# A303 Stonehenge

Amesbury to Berwick Down

Report on Public Consultation

**Appendix B**

## A303 Stonehenge - The proposed option

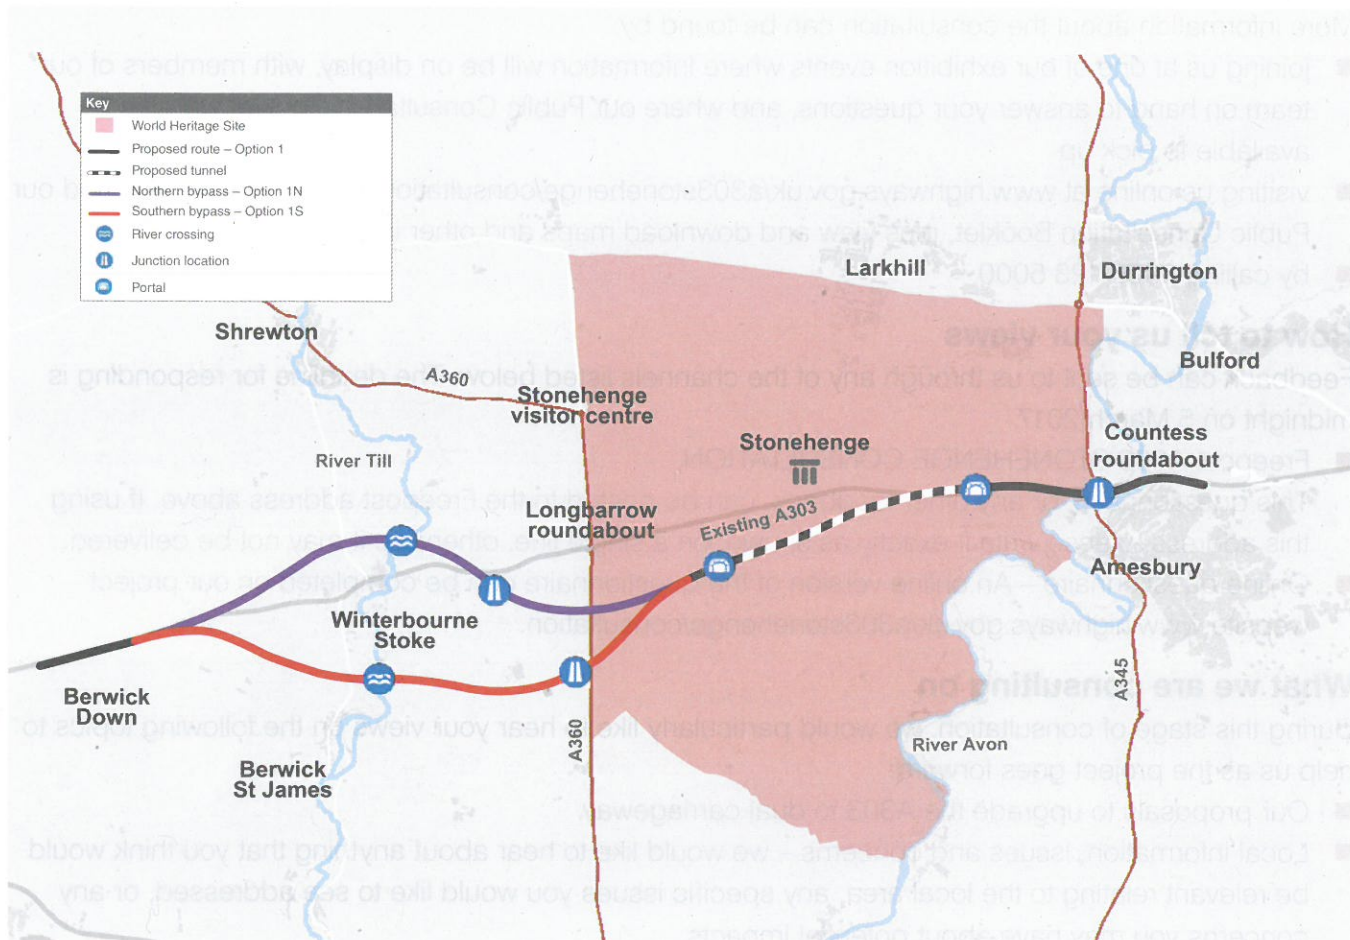
Please provide any comments to support your answer for Question 1

An A tunnel is not the optimal solution. Your posters state that 'traffic affects visitors' enjoyment' - have you done surveys that show this is the case? The A303 is over 1/4 mile away from Stonehenge. Most visitors will not be interested in walking miles to look at burrows, especially in the inclement weather of UK, so argument that current A303 splits Stonehenge site is irrelevant. Given that many of the items of archaeological interest will be underground, less damage would be done, & it would be cheaper, to widen the road instead.

Figure 1 - Seasonal change at Winterbourne Stoke on the River Till

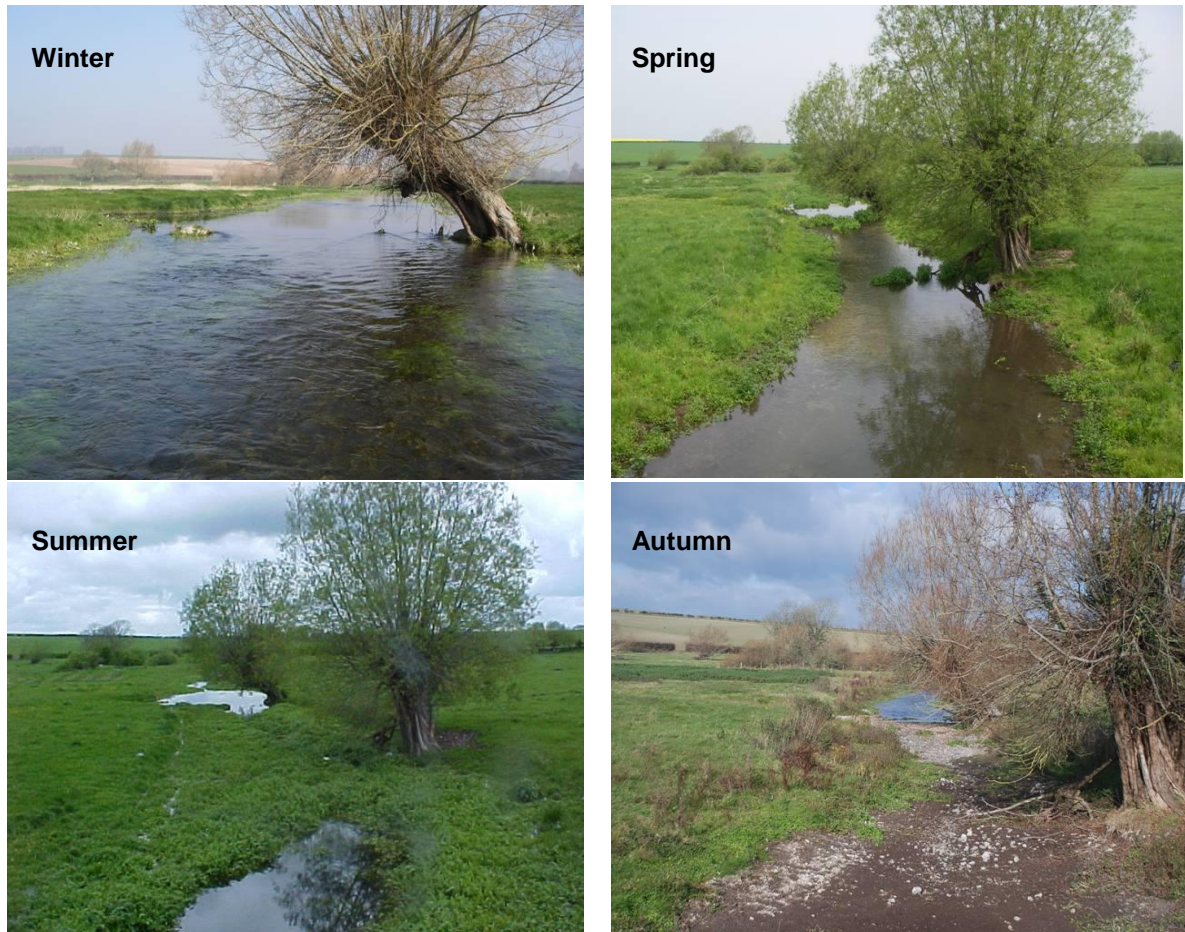
4. Within the middle section of the River Till, there is a junction of the upper and middle chalk layers in the vicinity of Berwick St James, resulting in a number of springs arising in and around the River (Plate 1), and forming a perennial head which is thought to typically arise in a wetland to the north of the Village. At this location, the soils of the River bed abruptly change from the gravel beds typical of the upper section, to clay based alluvium, which is likely to arrest any shallow subsurface groundwater flowing from the north, thereby contributing to the arising springs and marshy wetlands dominant in this section (see discussion on ecology below). The middle section of the River Till effectively functions as transitional zone between the upper winterbourne and the lower perennial sections, with the amount of aquifer recharge from yearly rainfall influencing both the amount of subsurface groundwater flowing from the northern upper section, as well as the pressure of the perennial head, both of which determine how far north and upstream perennial water in the middle section sits each year.

**Figure 1 The winterbourne signature from the River Till\***

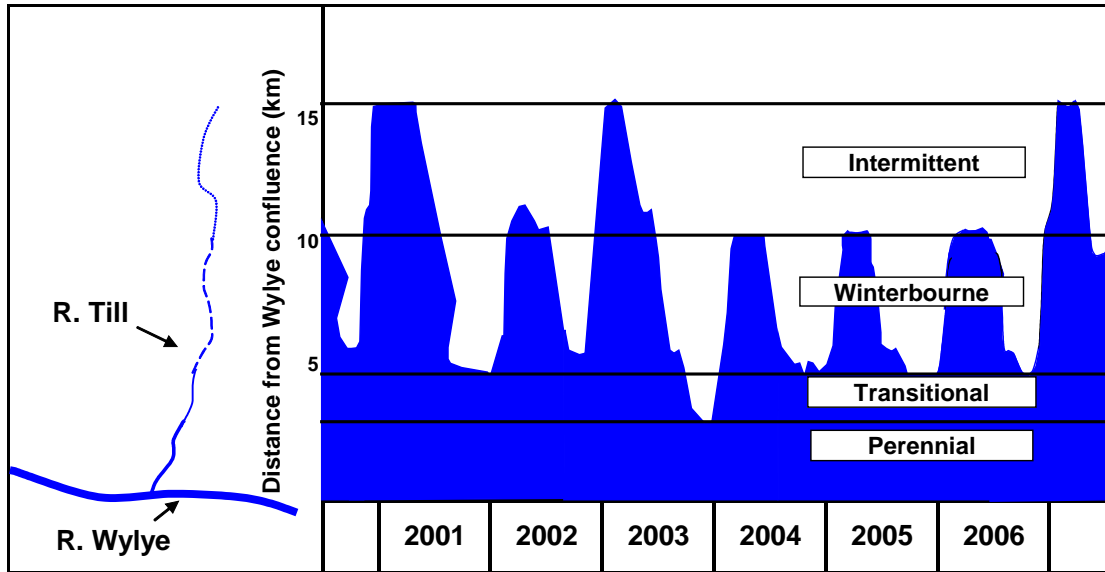
The winterbourne signature of the River Till is provided in Figure 1. The northern bypass viaduct is located approximately 6.5km from the R. Wylve, while the southern viaduct is located approximately 2km further downstream at 4.5km from the R. Wylve.

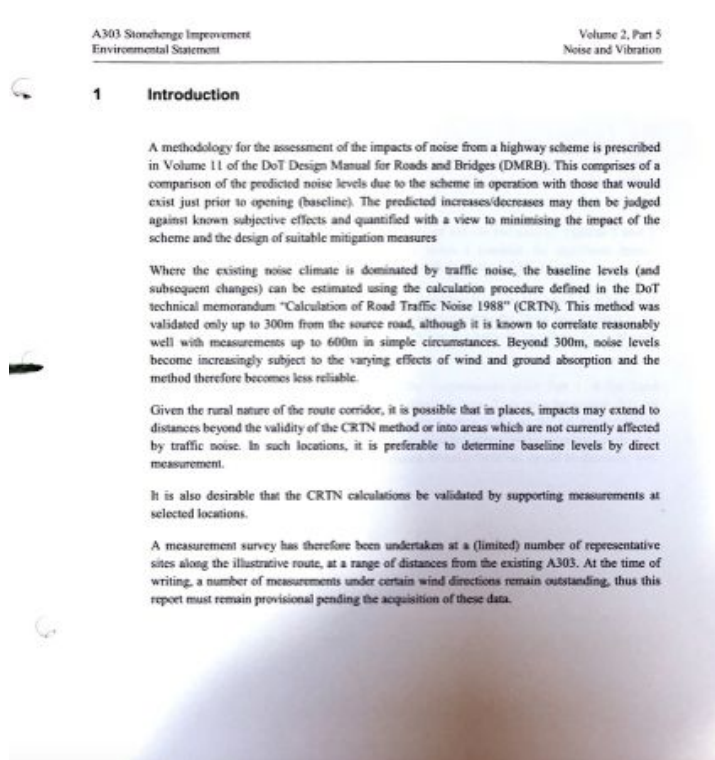
Highways England/Arup Atkins finally presented their noise predictions for sensitive receivers near the proposed routes, based on the use of CRTN. Whilst Highways England were very insistent that the CRTN process was followed, their interpretation of what was required appeared somewhat minimalist. For instance, the blocking of noise by buildings (facade effects) were omitted. Although these can be modelled in the CRTN methodology, it was ignored in this instance. This is likely to have distorted the noise predictions quite considerably. There were several other aspects of the use of CRTN which were questionable. The most concerning of these was the fact that no field sampling baseline data was collected in order to enable the modelling to be sanity tested and calibrated.

Worse still, no real attempt seems to have been made to make use of historical sampling data that could, in the very least, have assisted in this very purpose. Worryingly, for what is a company wholly owned by a Government department, Highways England claimed to no longer have a copy of the Environmental Impact Assessment conducted for the previous scheme in 2003, and which had been commissioned by their predecessor organisation at public expense. This claim alone should raise concerns. Needless to say, we were able to locate a publicly available copy of the EIA in a matter of a few minutes; a copy that would have been accessible to Highways England had they sought it. This calls into question the due diligence of Highways England and its contractors in seeking historic, but still valuable, data.

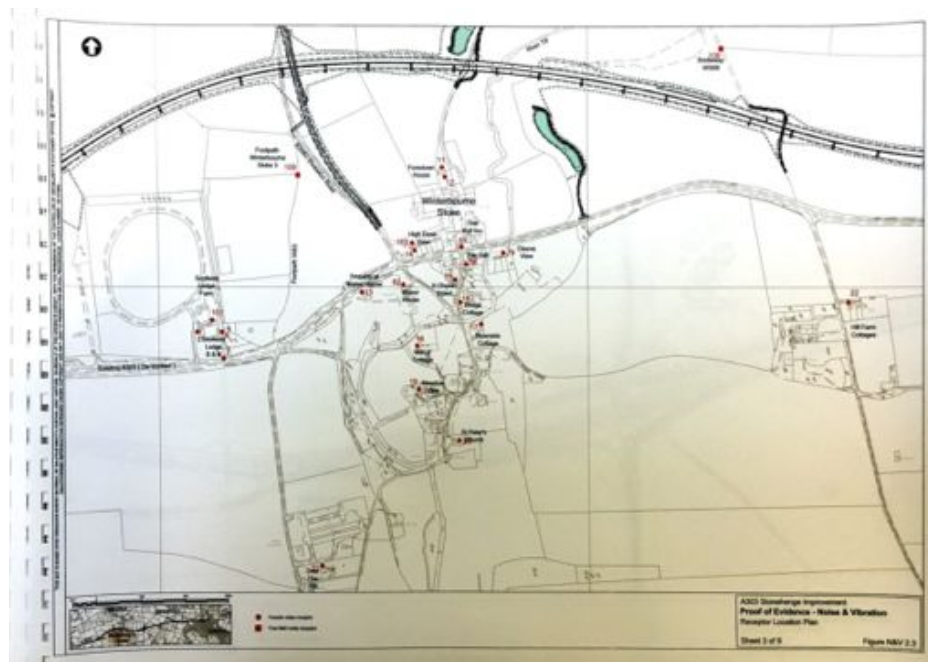
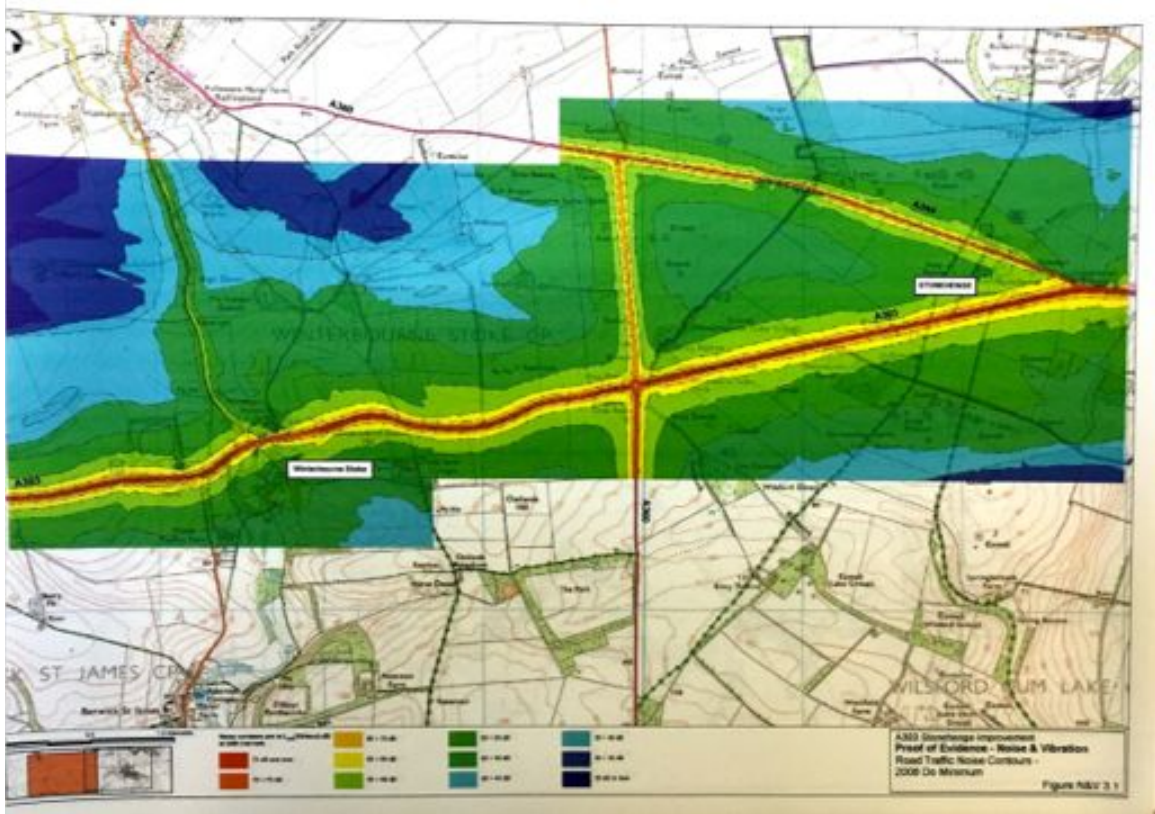
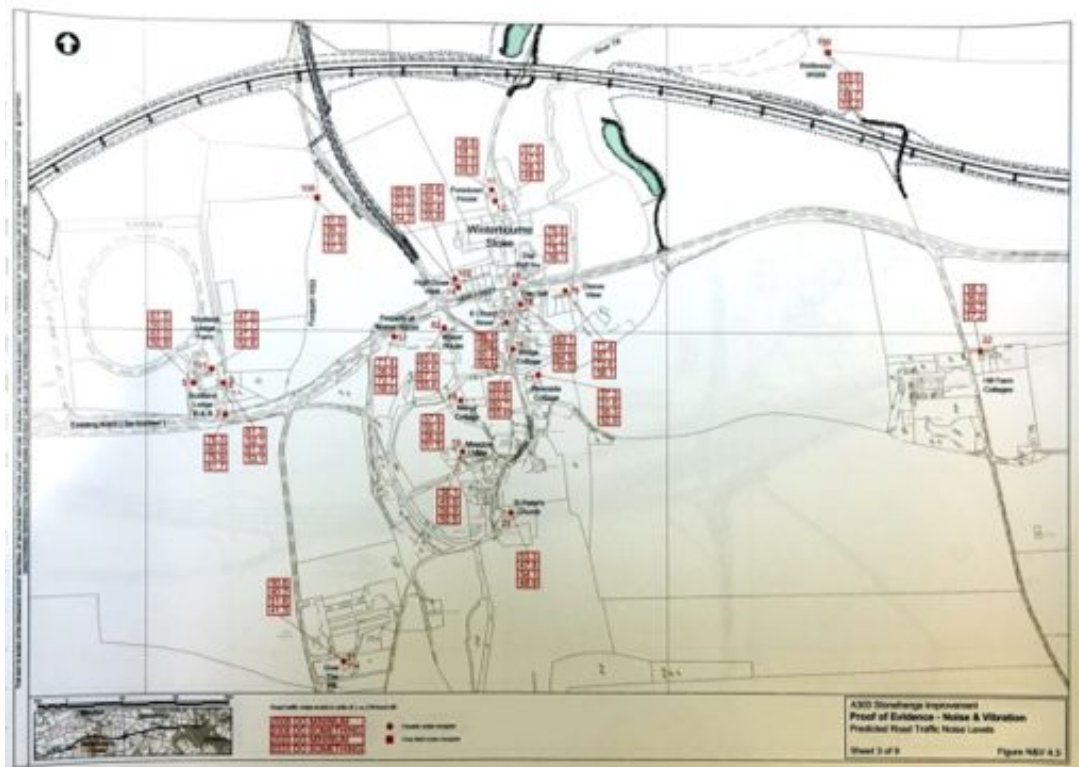
We note that in the Introduction to the 2003 Environmental Statement Volume 2 Part 5, above, there were numerous caveats that support our contention that Highways England have failed to employ CRTN effectively and appropriately, including: “It is desirable that the CRTN calculations be validated by supporting measurements at selected locations”. Or: “At the time of writing, a number of measurements under certain wind directions remain outstanding...” So, it is quite clear that best practise involves validating CRTN calculations against real world data and also means that the local meteorology needs to be

taken into account. The only shortcoming in the 2003 evaluation was the use of Met data from RAF Lyneham, almost 40km to the north.

It would have been useful had Highways England been able to produce information like that shown above to illustrate the baseline data as done here.
